Response to Comments Final Environmental Impact Report for the Balboa Park Plaza de Panama Project

**Project No. 233958
SCH No. 2011031074**

BALBOA PARK PLAZA DE PANAMA PROJECT

Response to Comments

EXHIBIT 1 - GOLD GULCH ALTERNATIVE GRADING PLAN

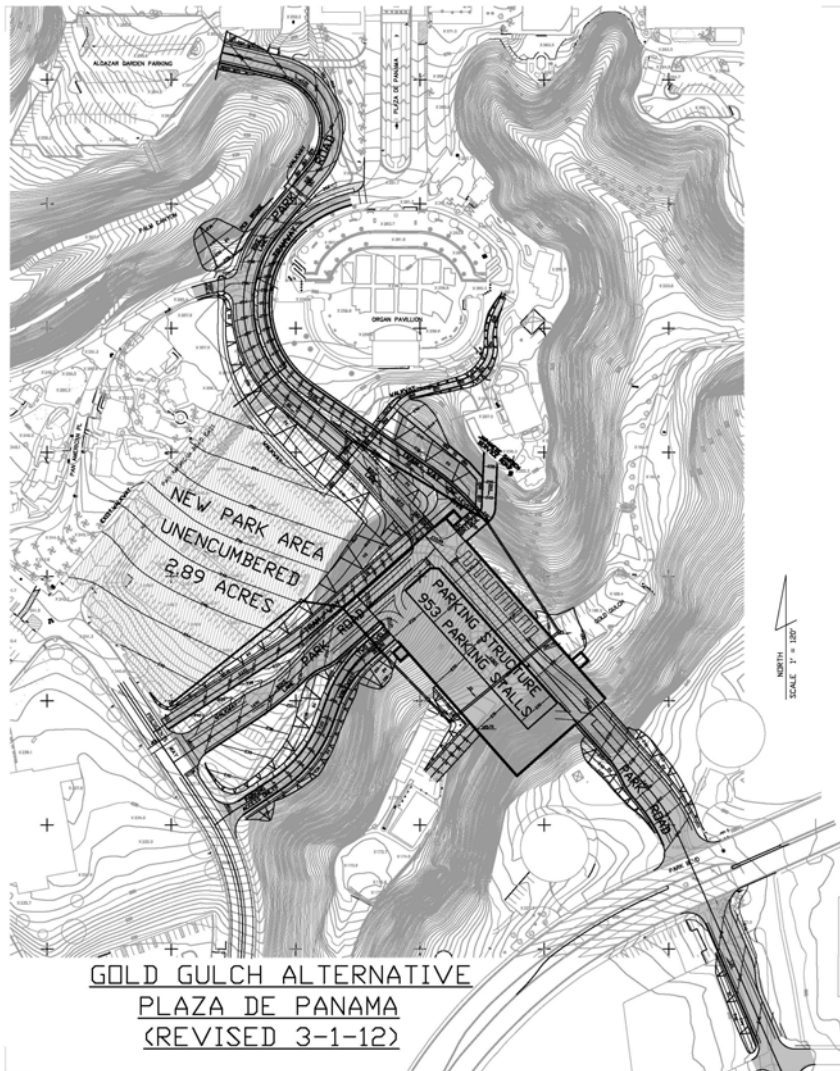
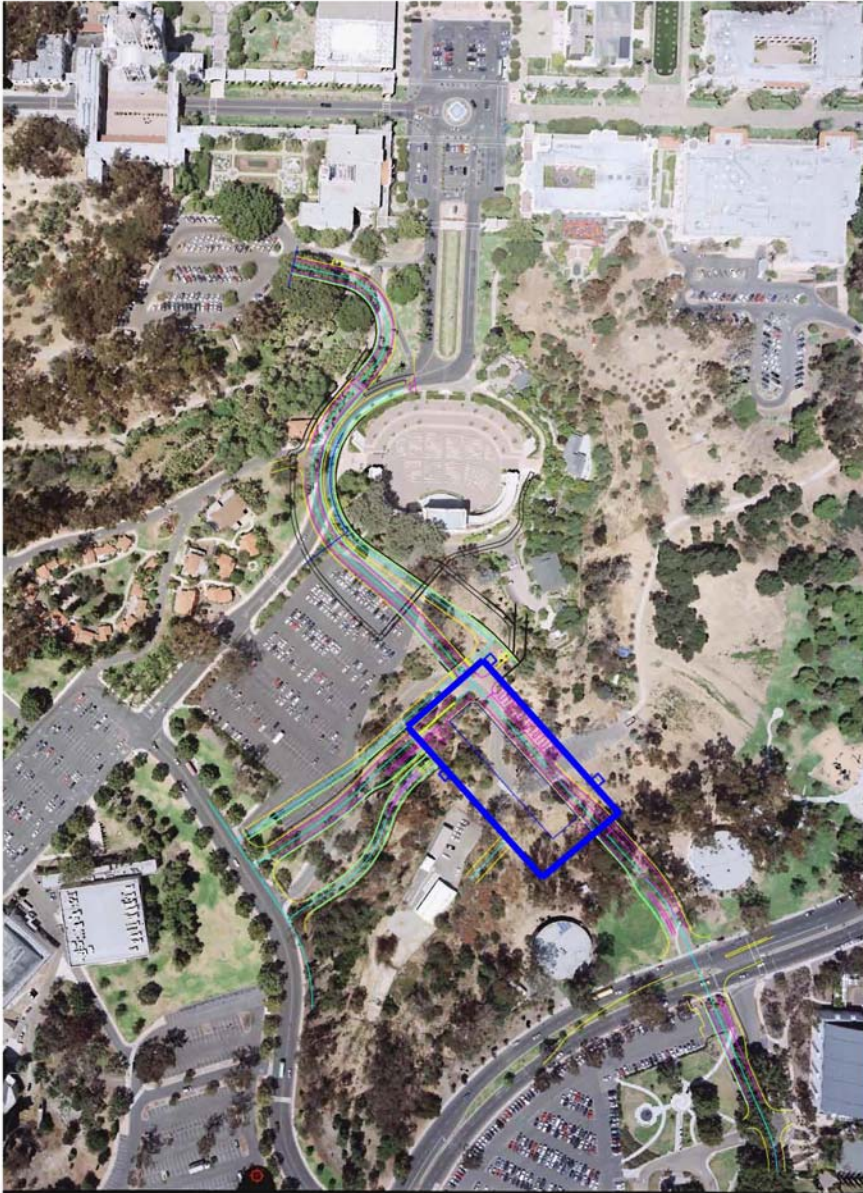
2. *"The Organ Pavilion parking lot would be converted to parkland, and green space would be added behind the Organ Pavilion."* This is correct, but it fails to point out that 2.9 acres of new, usable park land would be created by the Gold Gulch Alternative which would not be restricted in its potential use (see Exhibit 1). This new park land would not only be an increase of 0.7 acre over the Proposed Project; it also would be much more valuable park land since there would be no physical constraints to any use. Without having the limitation of building on the

Based on review of the attached plans, the suggested alternative would likely result in greater impacts in each of these four areas.

FIGURE 3-32
Proposed Pedestrian Circulation

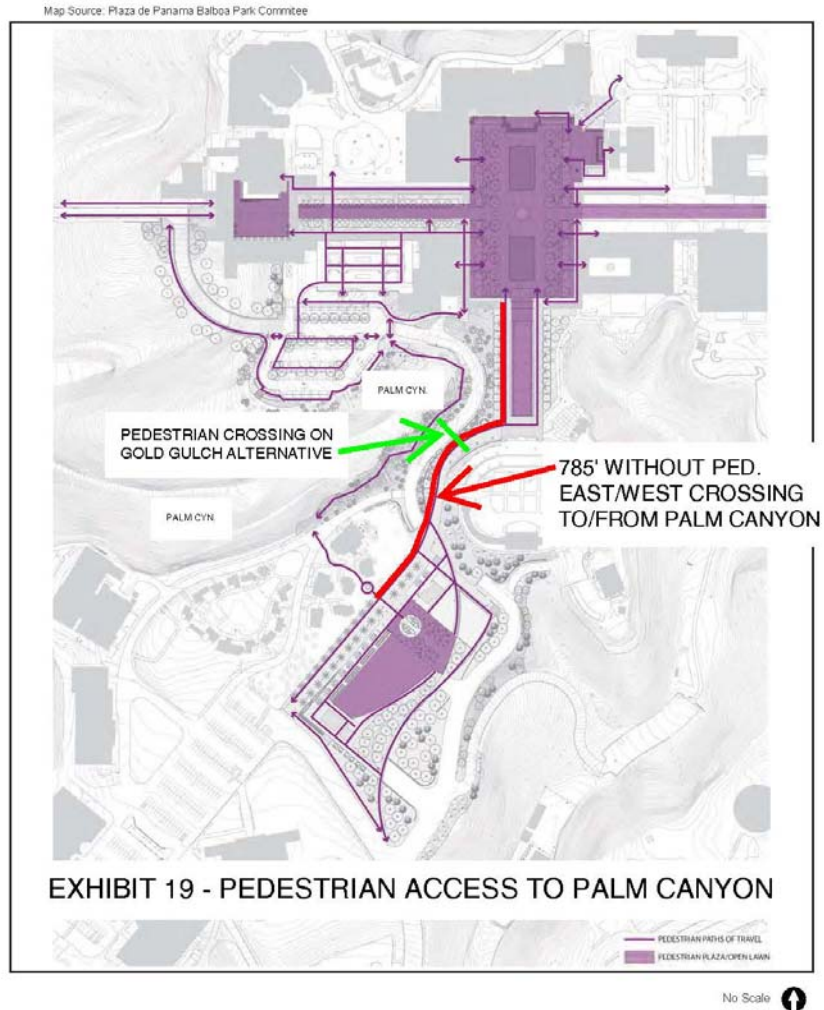
DEIR Part 2, Sec. 3.4.4, Project Description, Alcazar Parking Lot, Fig. 3-19, Proposed ADA Accessible Routes & DEIR Part 2, Sec. 3.4.7.3 a, Project Description, Parking, Proposed Parking Changes, Fig. 3-32, Proposed Pedestrian Circulation	Figures 3-19 shows no ADA access along El Prado through the Plaza de California, implying that one must use the Centennial Bridge for access to the Central Mesa area. Figure 3-32 shows no general (non-ADA) access along that route. Is that intended?
---	--

For clarification purposes, Figure 3-19 has been revised to show the Plaza de California as an accessible plaza and to illustrate an uninterrupted ADA accessible path of travel from the western end of the Cabrillo Bridge through the Plaza de California. This revision to the Final EIR provides clarification and consistency between text and graphics.
